*Private Fuel Storage, L.L.C.*

COMMITMENT RESOLUTION LETTER #9  
DOCKET NO. 72-22/TAC NO. L22462  
PRIVATE FUEL STORAGE FACILITY  
PRIVATE FUEL STORAGE L.L.C.

Figure I-2. Survey of Airways in the Vicinity of the TOCDF/DCD

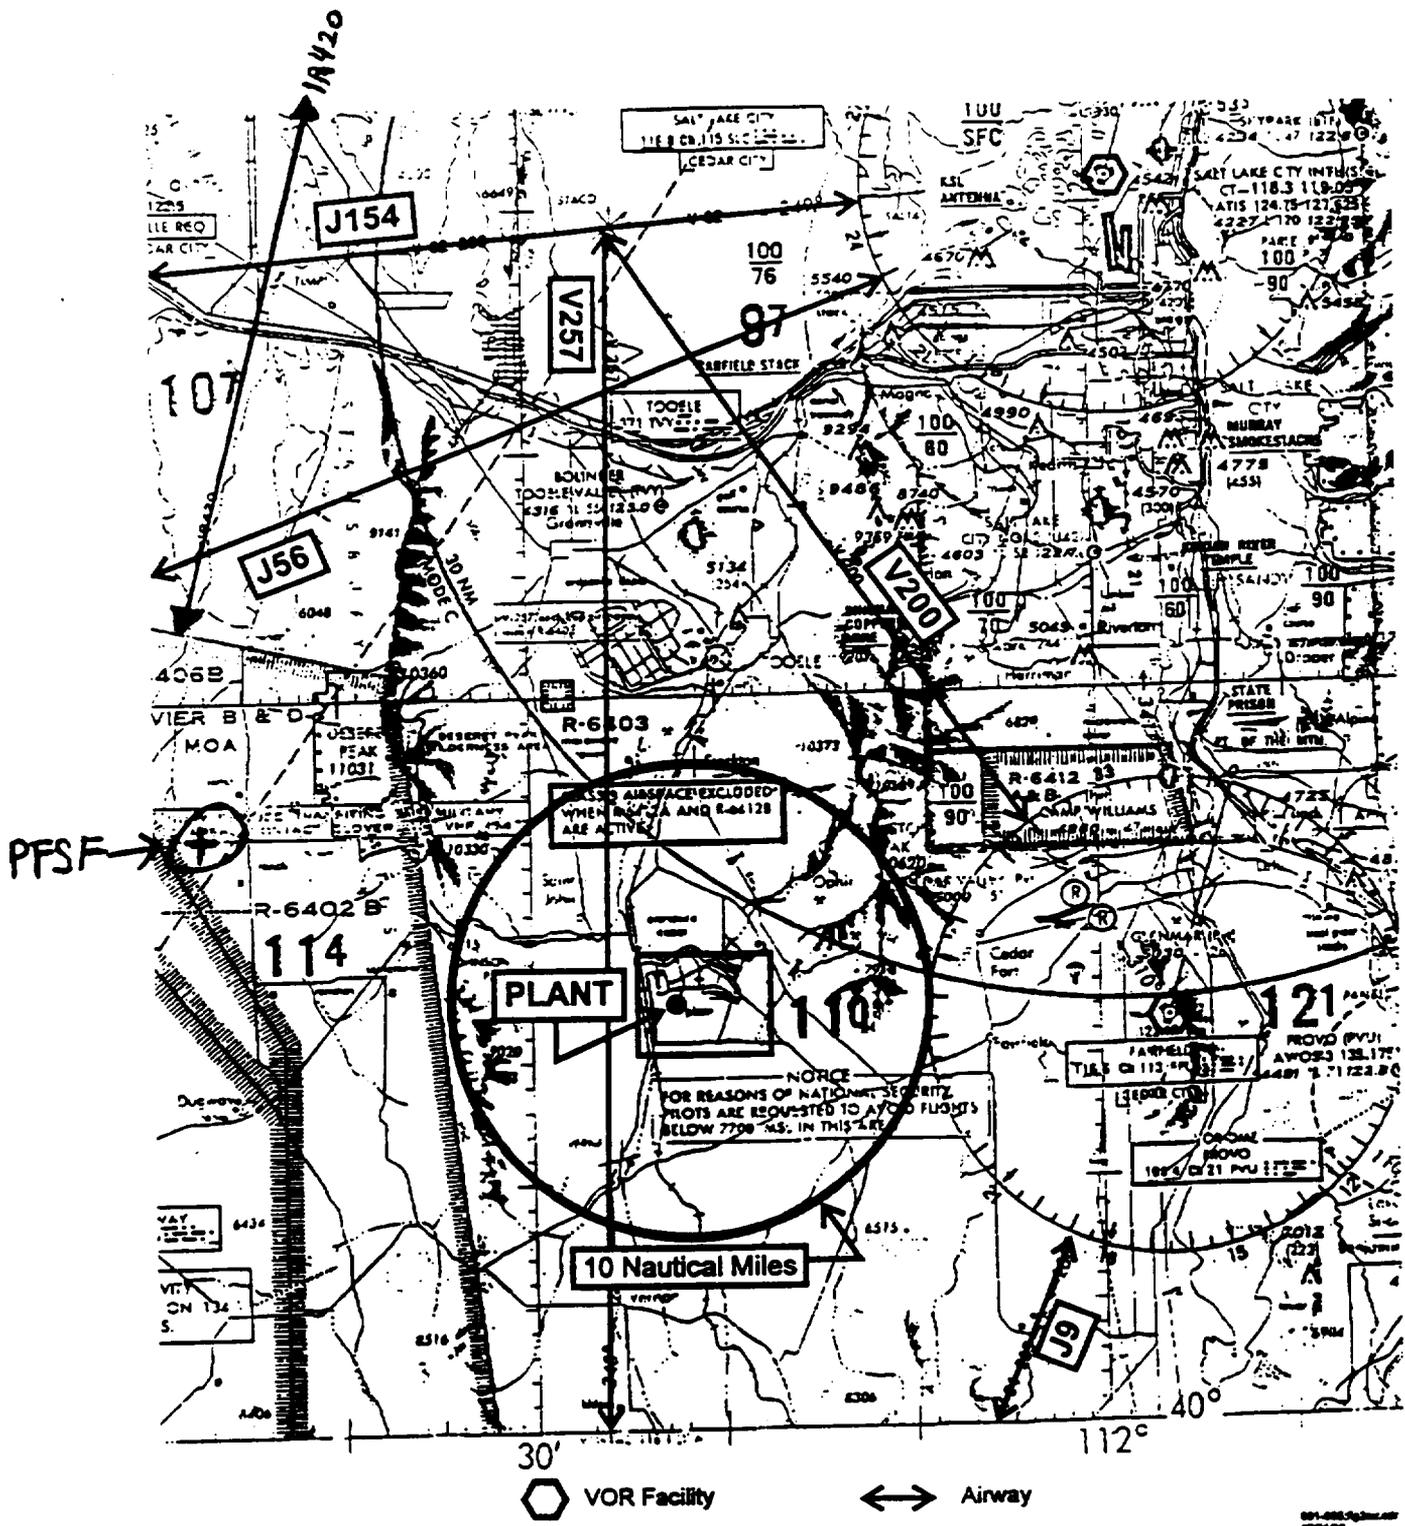
In our phone call this afternoon, the NRC requested two items to clarify materials previously sent to the NRC: a map showing airways in the vicinity of the Private Fuel Storage Facility (PFSF), and the source of information regarding the flight path of F-16s traversing Skull Valley.

Response 1: PFS is providing a map showing the airways in the vicinity of the site to enable one to visualize where the airways, described in General Cole's June 3, 1999 "Risk Assessment of Credible Aircraft or Missile Accidents Impacting [the PFSF]," are located vis-à-vis the PFSF site. The map is from a 1996 Quantitative Risk Assessment for the Tooele Chemical Agent Disposal Facility (denominated as the "Plant" on the map, but which is not the PFSF) prepared by Science Applications International Corporation for the U.S. Army. We have added to the left side of the map the location of the PFSF site and airway IR 420.
